Pike Place Market Historical Commission

MHC 128/11

The Pike Place Market Historical Commission identified inadequate evaluation of potential adverse effects to the Pike Place Market Historic District (Attachment A) in the Alaskan Way Viaduct Replacement Project Final Environmental Impact Statement and requests that additional information be included in the Project's Record of Decision.

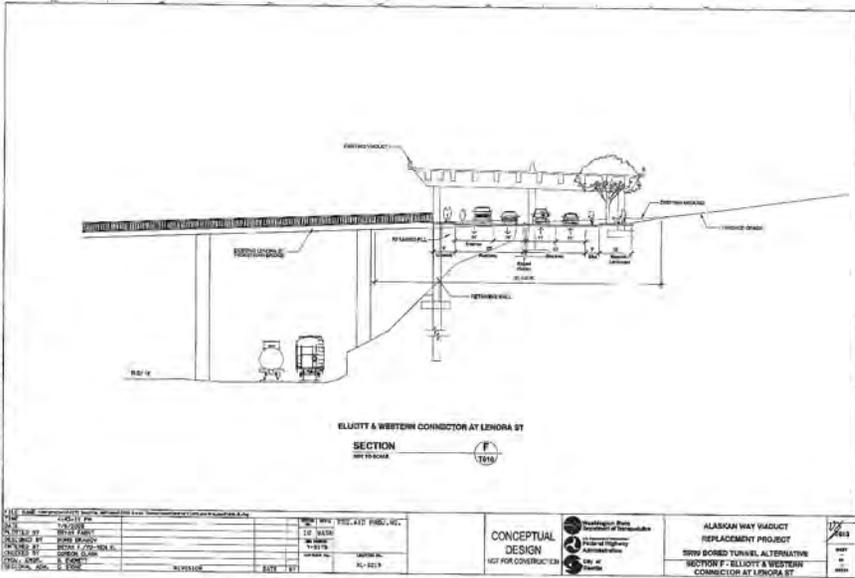
Constructive use of Pike Place Public Market under Section 4(f) of the National Transportation Act through construction activities at Victor Steinbrueck Park, the PC-1 Site, and Western Avenue due to Alaskan Way Viaduct demolition and Elliott/Western Connector work is not identified in the FEIS Exhibit 4(f)-2. Preliminary Elliott/Western Connector drawings prepared in 2009 by Boris Dramov for FHWA, WSDOT, and SDOT (Attachments B-E) were not identified in Appendix C (Exhibit 1-1, page 1-8) of the FEIS under transportation discussion.

16) Portions of Western Avenue within the Pike Place Public Market Historic District would be subject to use under Section 4(f) under the preferred alternative through the Elliott/Western Connector work. FHWA responsibility for the Elliott/Western Connector Section 4(f) evaluation remains unclear. These were not identified in the FEIS Exhibit 4(f)-2.

The 2009 drawings that show the Elliott/Western Connector are not drawings of the Bored Tunnel Alternative. Both the Cut-and-Cover Tunnel and Elevated Structure Alternatives include connections to Elliott and Western Avenues. However, the Elliott/Western Connector is not a part of the Bored Tunnel Alternative (see Appendix B, Alternatives Description and Construction Methods). Since the Elliott/Western Connector is not part of the Bored Tunnel, it is not included in the Section 4(f) evaluation of that alternative.

The Section 4(f) analysis in the Final EIS does not consider the Elliott/Western Connector because it is not part of the proposed action. The Elliott/Western Connector is an independent project that will be evaluated through its own environmental review process. Information related to level of service and intersection delay expected at several intersections along Western Avenue with the proposed action is provided in the Final EIS Exhibits 5-12 and 5-13, and Appendix C, Transportation Discipline Report, specifically Sections 5.3 and 7.4 and Exhibits 5-28 and 7-57. These data indicate that intersection delay at intersections along Western Avenue are expected to be similar between the Tolloed and Non-Tolloed Bored Tunnel.
